11/22/2024

Re: Docket No. 508 - The United Illuminating Company Application for a Certificate of Environmental Compatibility and Public Need for the Milvon to West River Railroad Transmission Line 115-kV Rebuild Project – Notice for Modification to Segment 3 (Allings Crossing Substation to Woodmont Substation)

UI 115-KV RR PROJECT MILVON TO WEST RIVER DEVELOPMENT & MANAGEMENT PLAN					
DR.	SFB	SCALE	AS SHOWN	FILE:	
CK.	JRD			NO.	
APP.	MSP				
REV.	0-0E				
MAPSHEET 21 OF 21					
REV.	0-0E

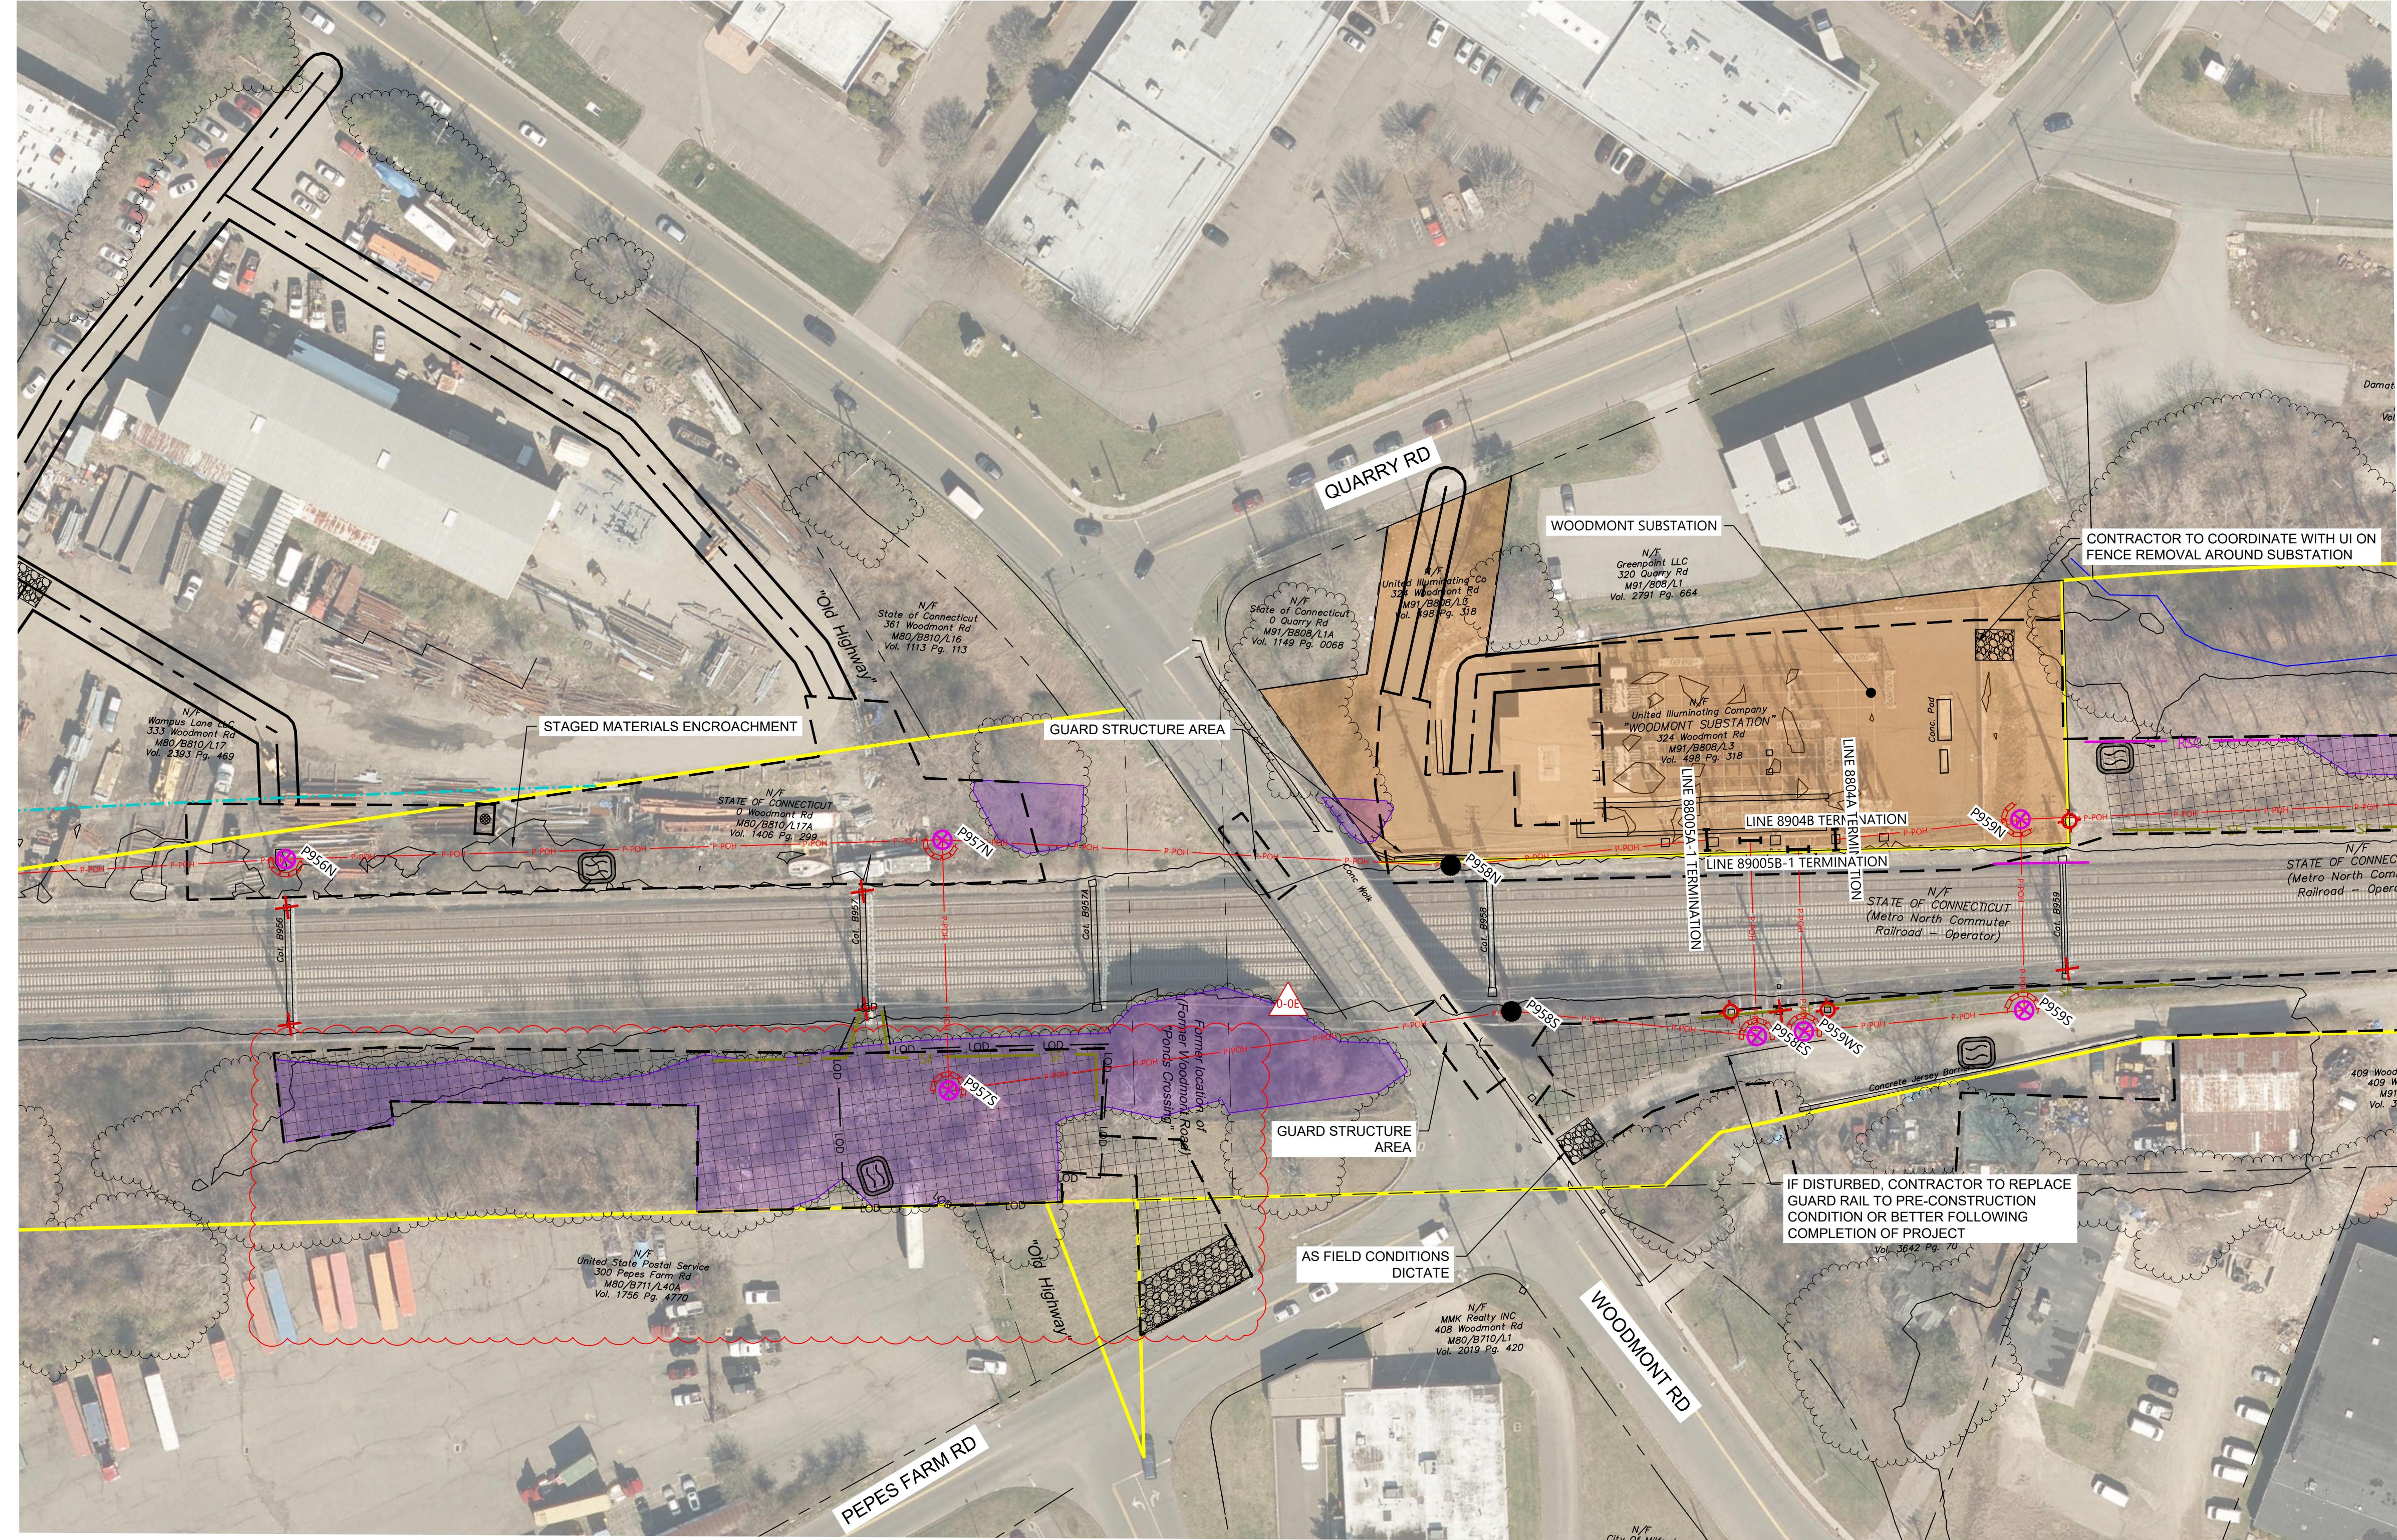
Pursuant to the Regulations of Connecticut State Agencies Section 16-50j-62(b)(2) and Attachment M to the project's Development & Management Plan, The United Illuminating Company ("UI") is hereby requesting a modification from the Connecticut Siting Council (the "Council"). The modification is associated with the work pad planned to be utilized during the construction of structure P957S.

After a value-engineering review, it was determined that the shifting of the temporary work pad associated with structure P957S would reduce risk to the schedule by avoiding the need for unnecessary land rights; specifically, the access road located east of 300 Pepes Farm Road. The expansion of the temporary work pad is also necessary to support conductor pulling as part of a 4-track crossing and will require additional uplands clearing and disturbance. However, the Project remains well within its permitted limits.
